**METROPOLITAN GOVERNMENT OF NASHVILLE AND DAVIDSON COUNTY**

**STAFF RECOMMENDATION**  
**2012 Benjamin Street**  
**May 19, 2021**

**Application:** New Construction—Addition  
**District:** Eastwood Neighborhood Conservation Zoning Overlay  
**Council District:** 06  
**Base Zoning:** R6  
**Map and Parcel Number:** 08306016500  
**Applicant:** Greg Roth, Owner  
**Project Lead:** Sean Alexander, sean.alexander@nashville.gov

**1 SOUTH ELEVATION**

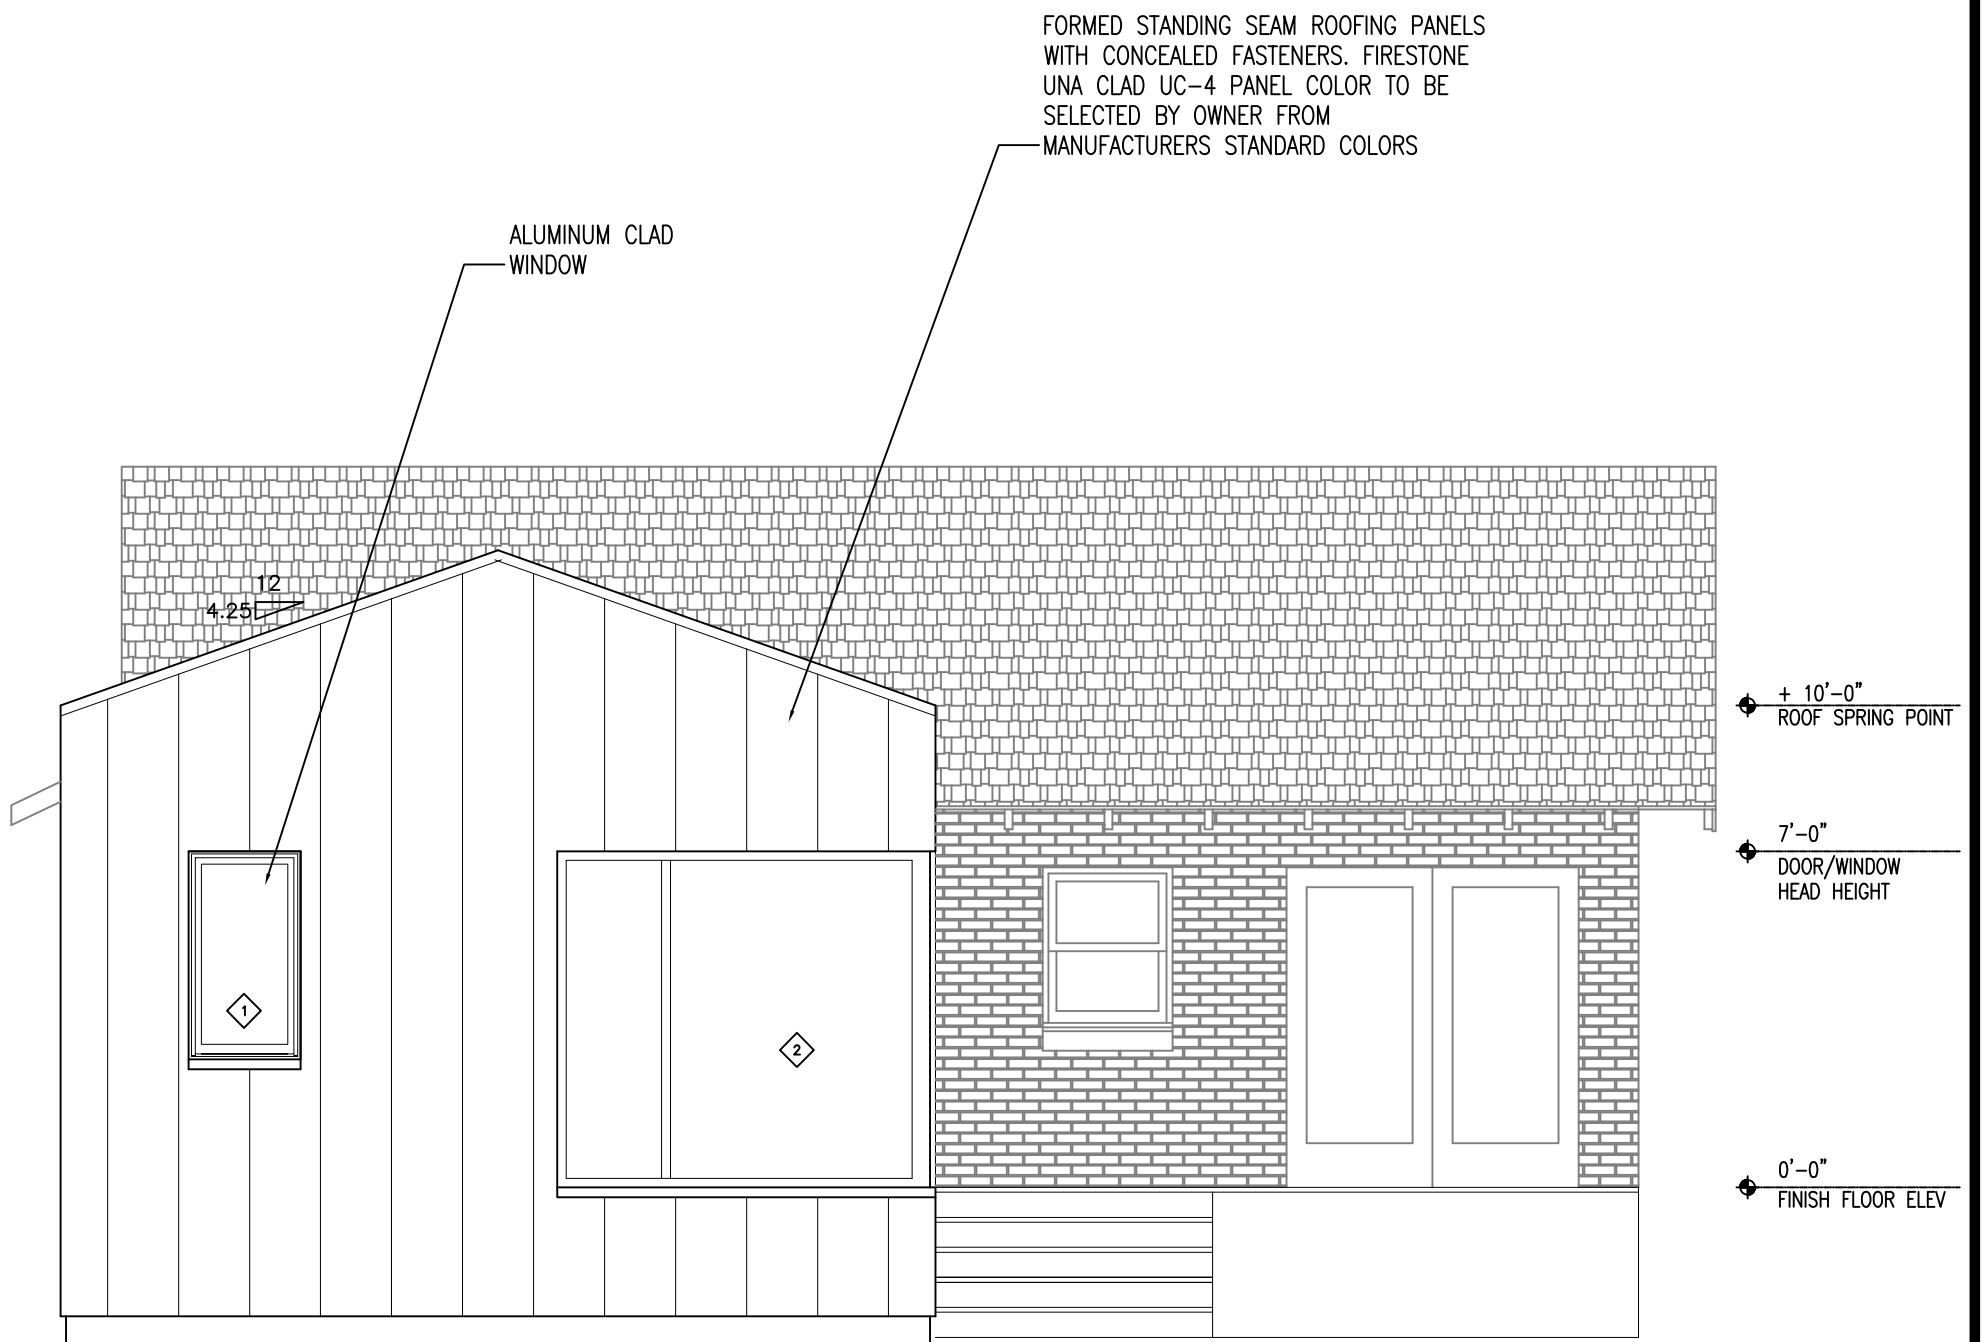
Standing seam metal is a common material for roofing, but not for siding. Staff recommends that the siding should be a more appropriate material, such as clapboard or board-and-batten, or another type of metal siding.

1. The addition steps in at least four inches (4”) where it attaches to the house on the right side;
2. The siding should be a more appropriate material, such as clapboard or board-and-batten, or another type of metal siding that has previously been approved.
3. The metal colors, siding, window and door selections, and exterior stair materials are approved prior to purchase and construction.
